Re: Addendum 3 RFP 22-05OPP Roof Replacement Thorburn Consolidated School

Re: Addendum 2 RFP 22-05OPP Roof Replacement Thorburn Consolidated School

Re: Addendum 1 RFP 22-05OPP Roof Replacement Thorburn Consolidated School

CONSTRUCTION PHOTOS FROM PREVIOUS PHASE AT THORBURN SCHOOL

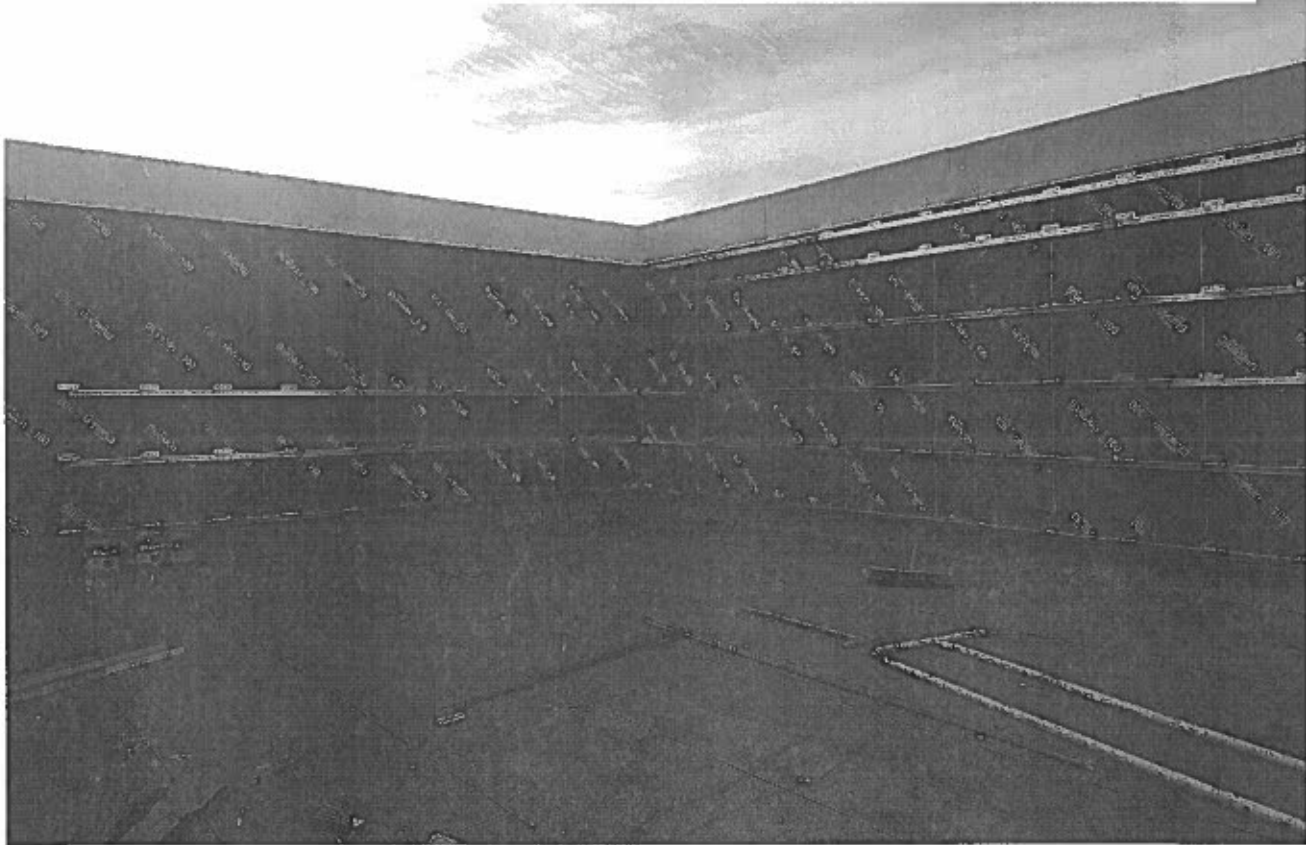
Install new cladding
around chimney (c/w
outside corner trims)

Edge of new cladding
(complete with
closure trim)

Install J/closure trims
at window jambs.
Install head and sill
flashings

Extend new cladding
to building corner;
terminate with
closure trim

CONSTRUCTION PHOTOS FROM PREVIOUS PHASE AT THORBURN SCHOOL

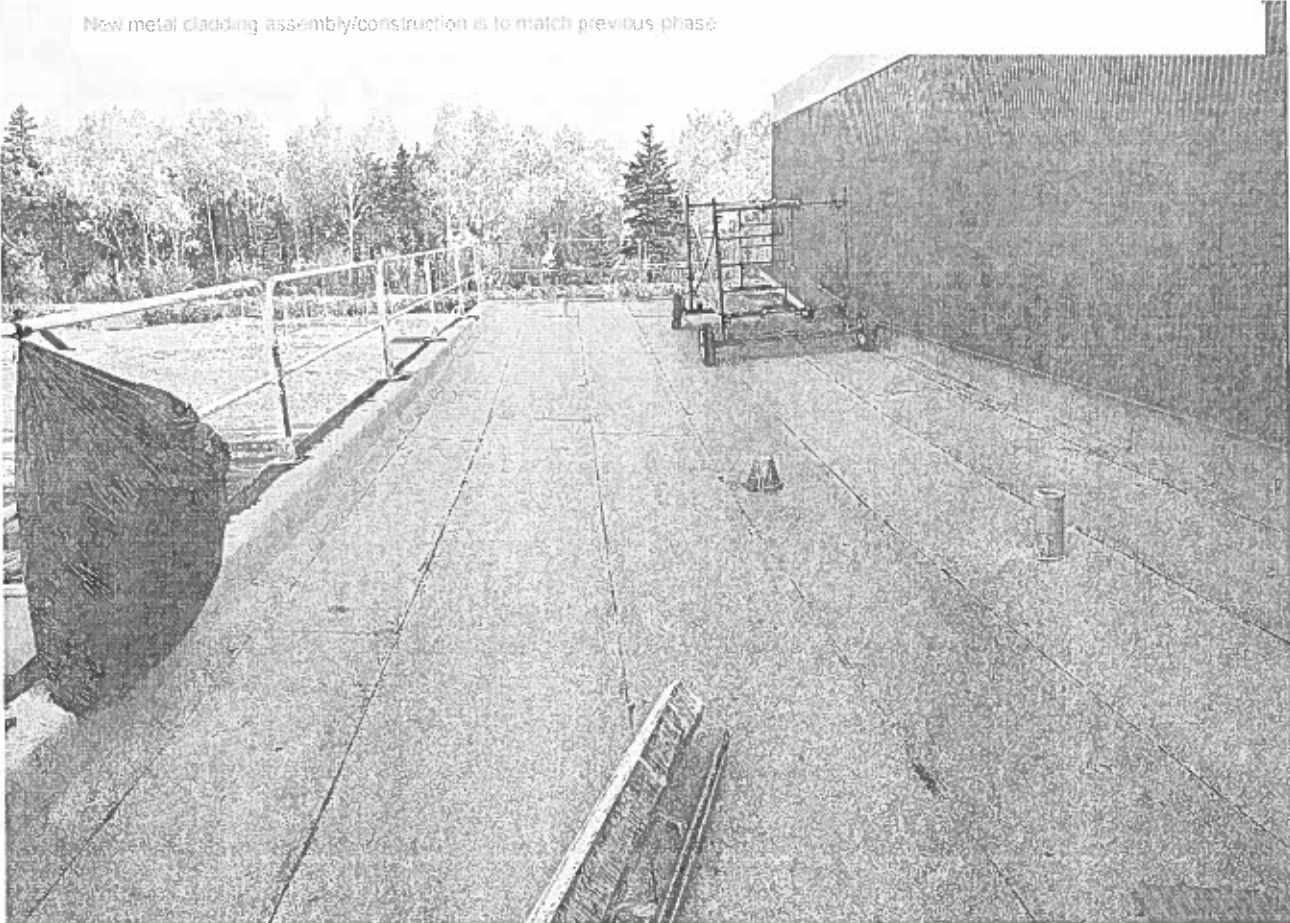
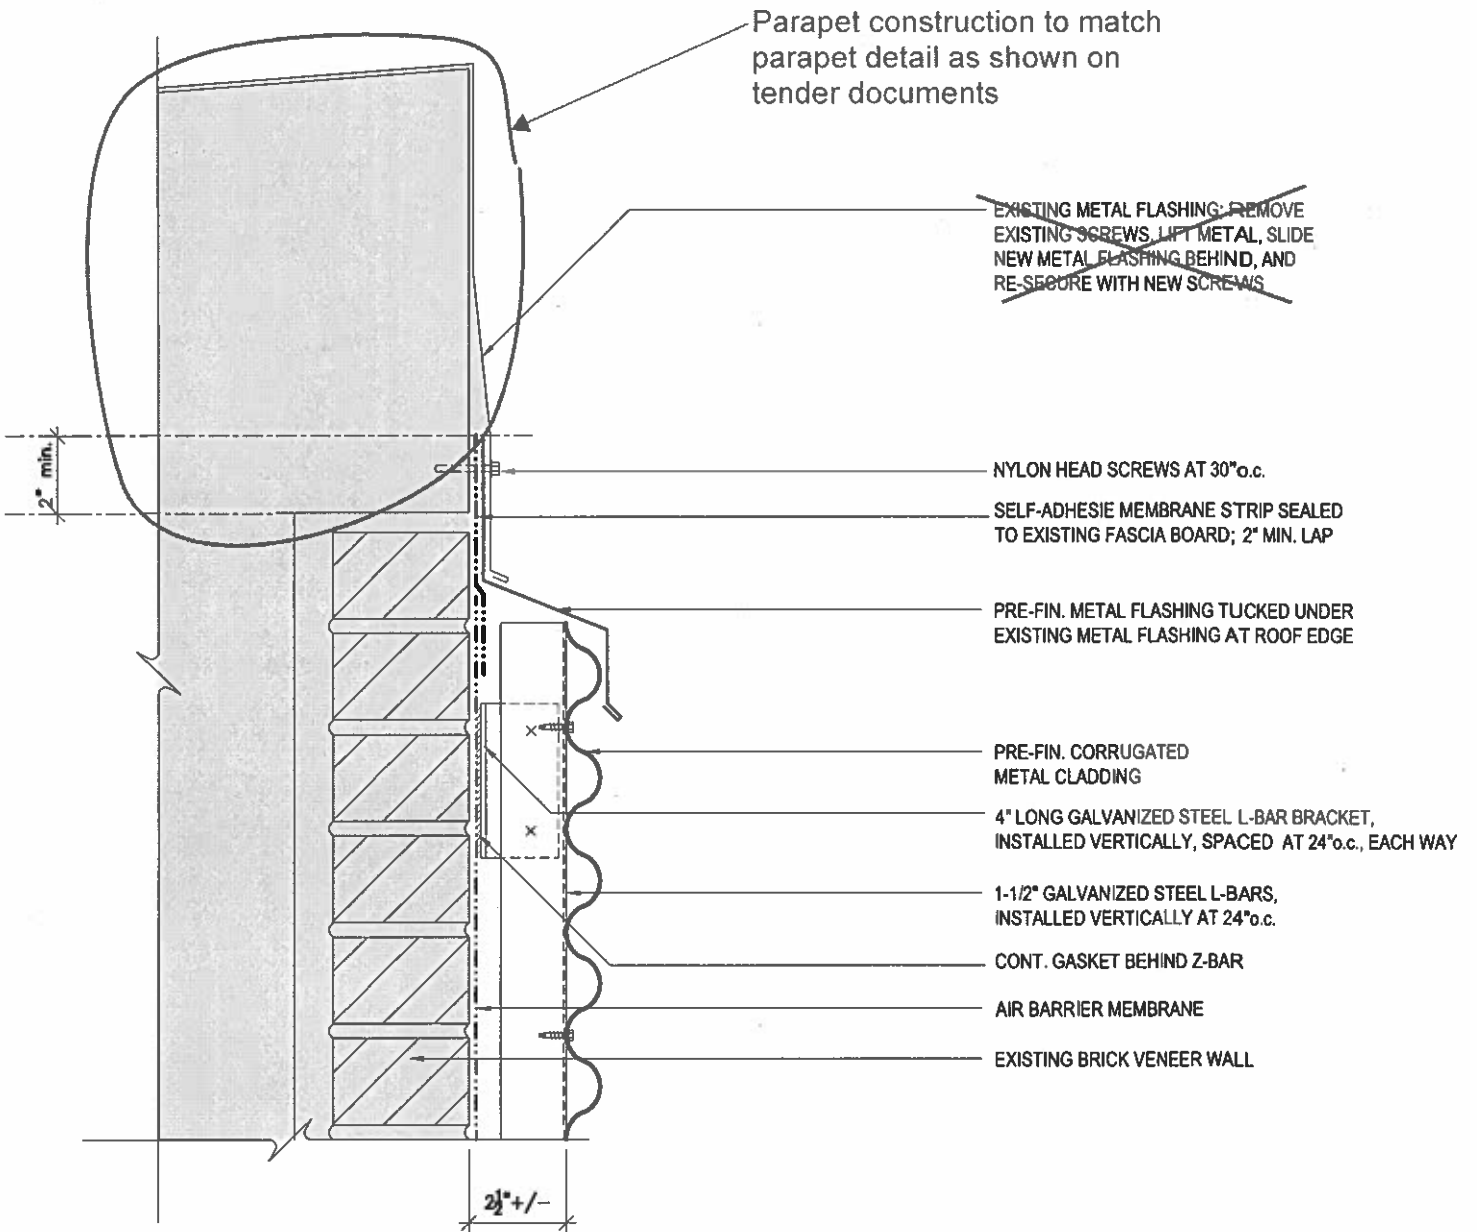
New metal cladding assembly/construction is to match previous phase

METAL CLADDING AT PARAPET

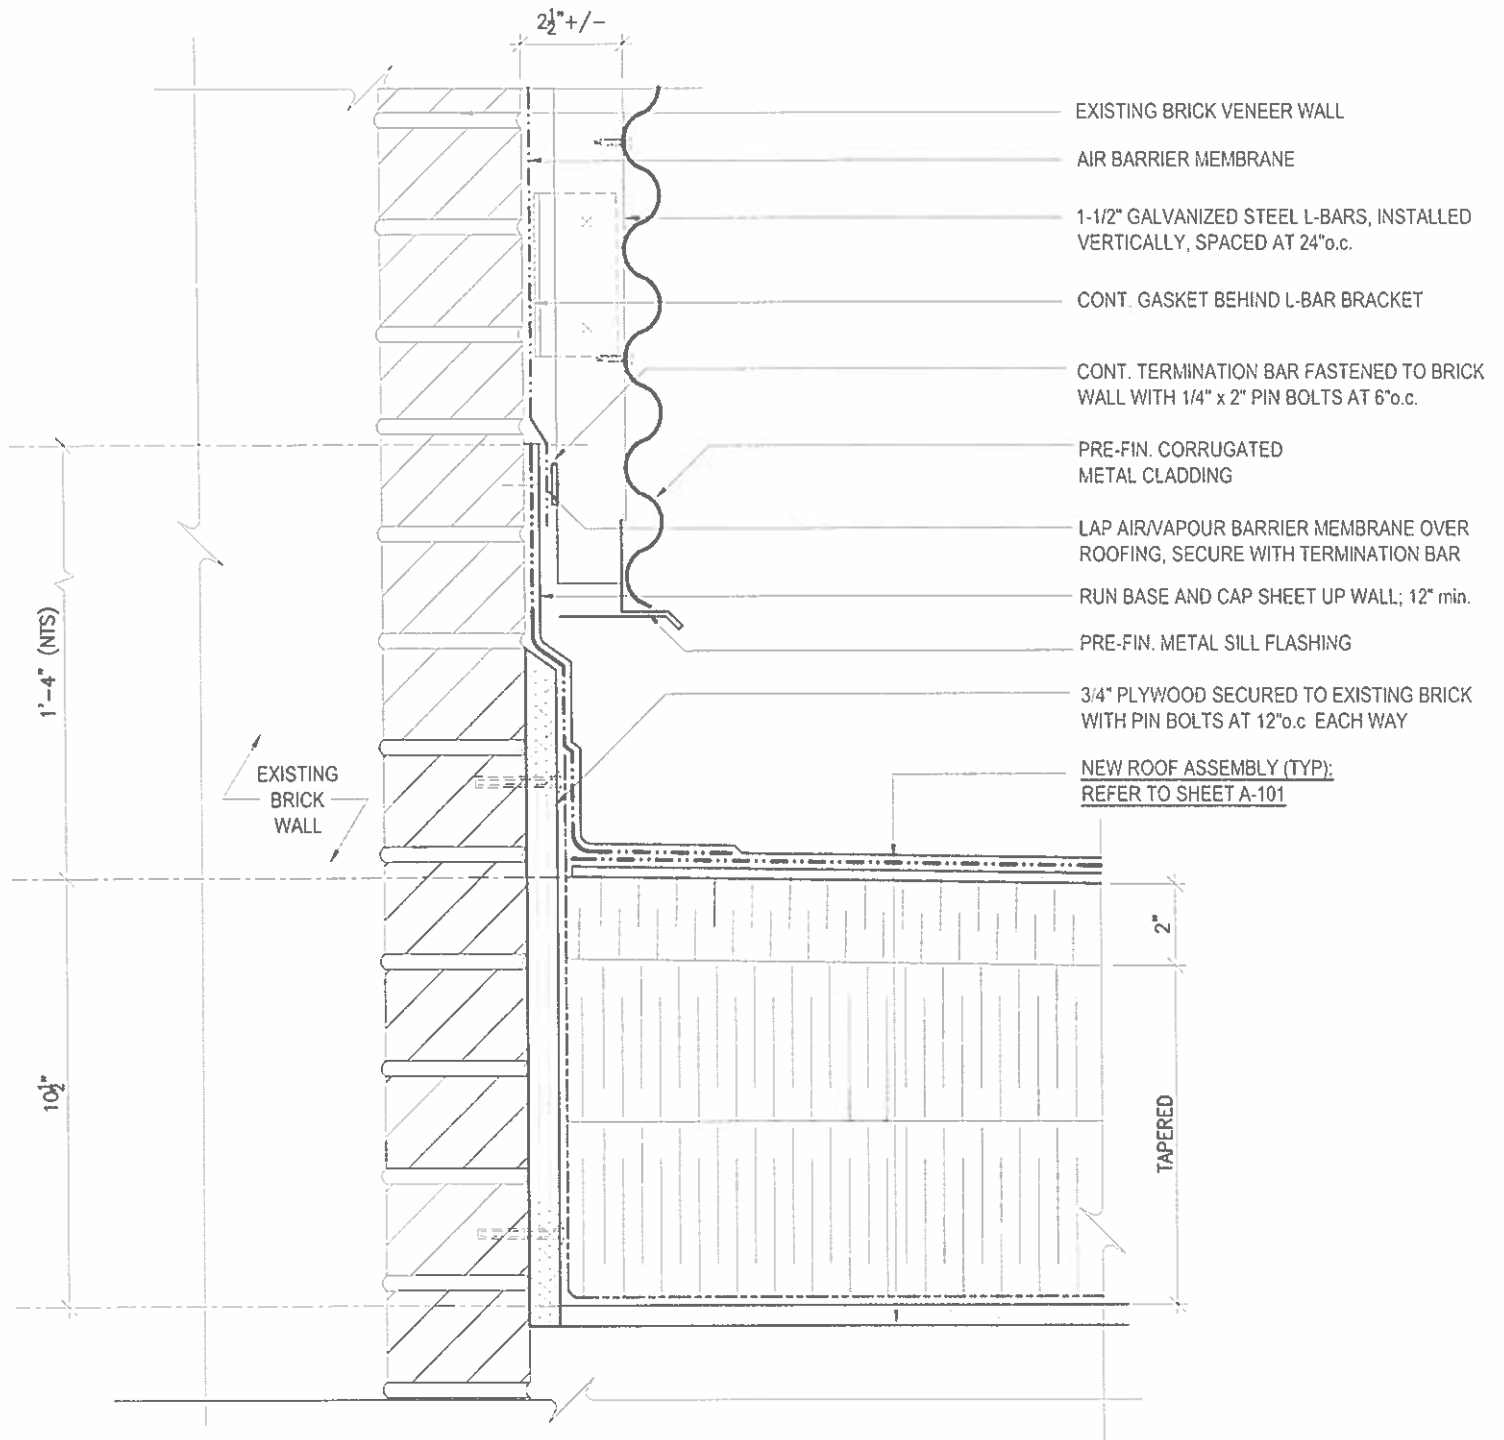
Note: This detail shows horizontal cladding on vertical girts; install vertical cladding on horizontal girts (as shown in CONSTRUCTION PHOTOS)

METAL CLADDING AT BASE OF WALL

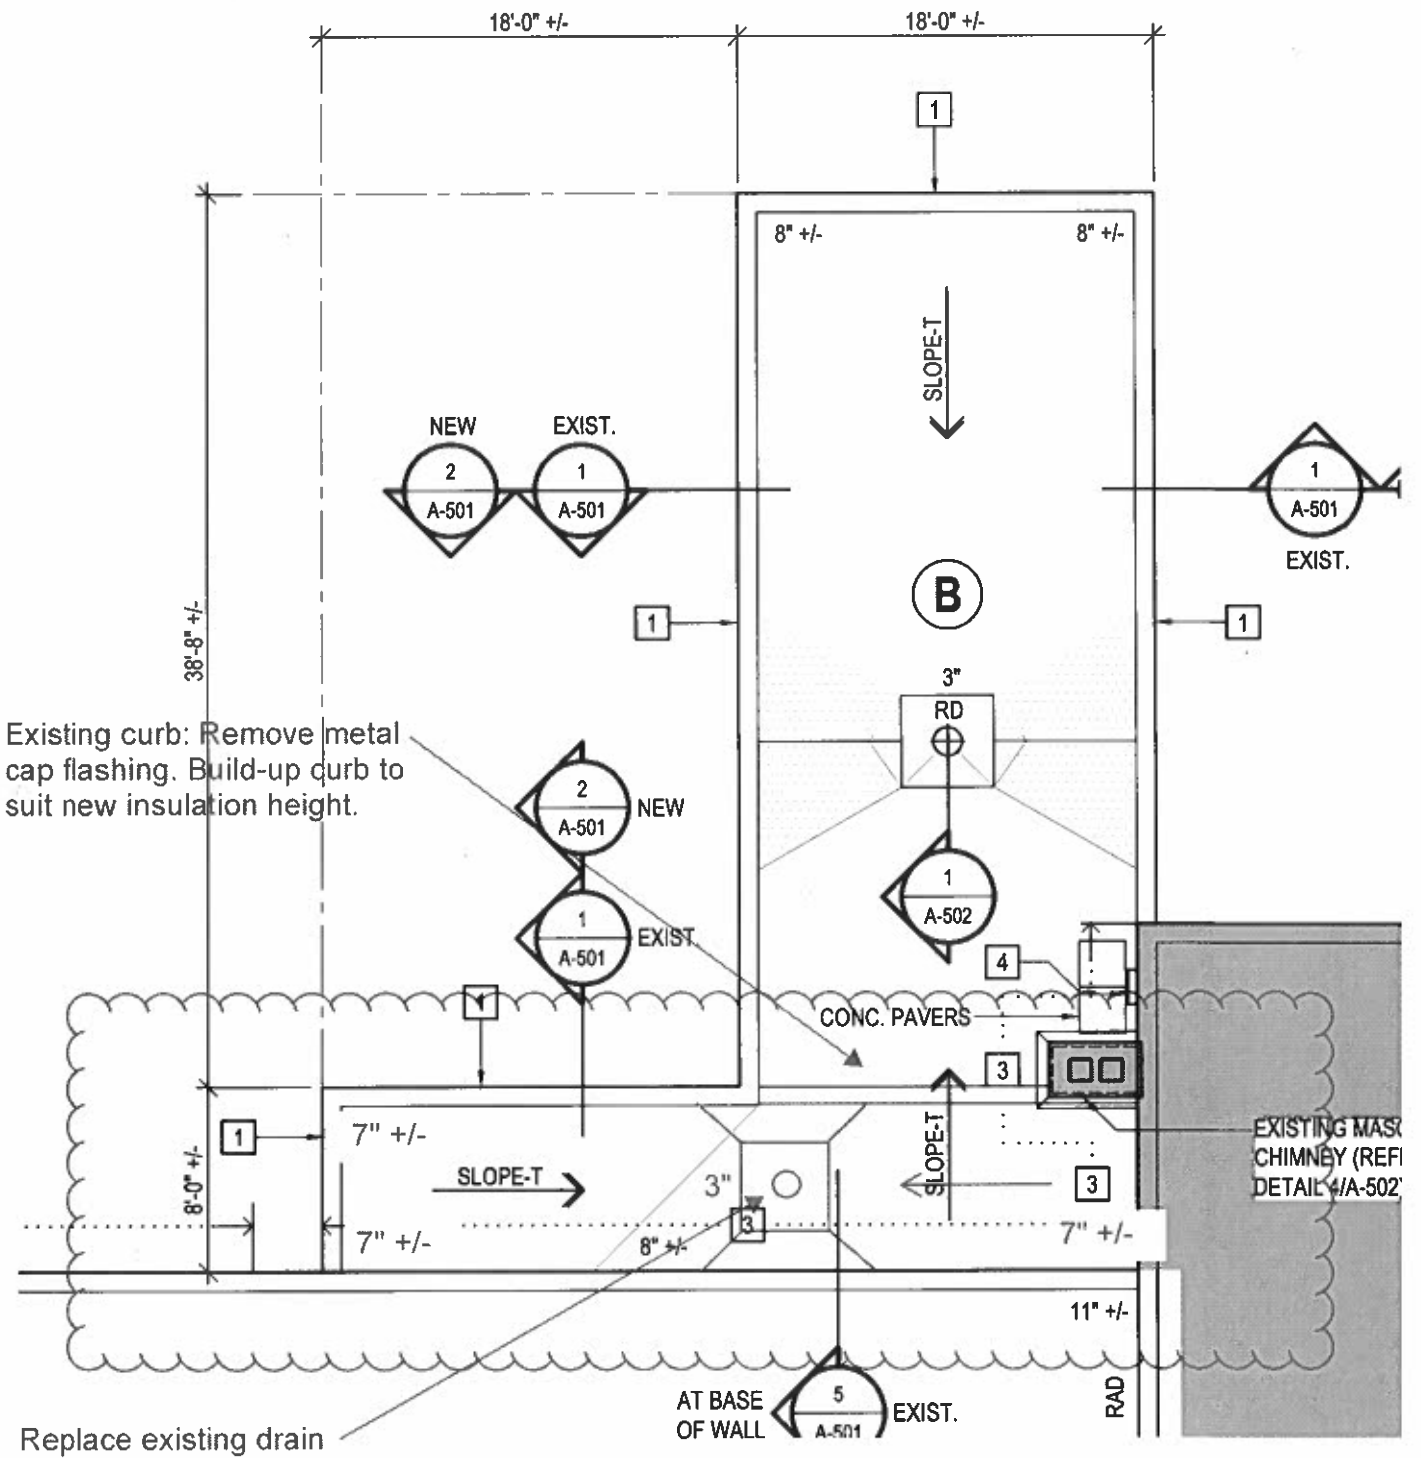
Note: This detail shows horizontal cladding on vertical girts; install vertical cladding on horizontal girts (as shown in CONSTRUCTION PHOTOS)
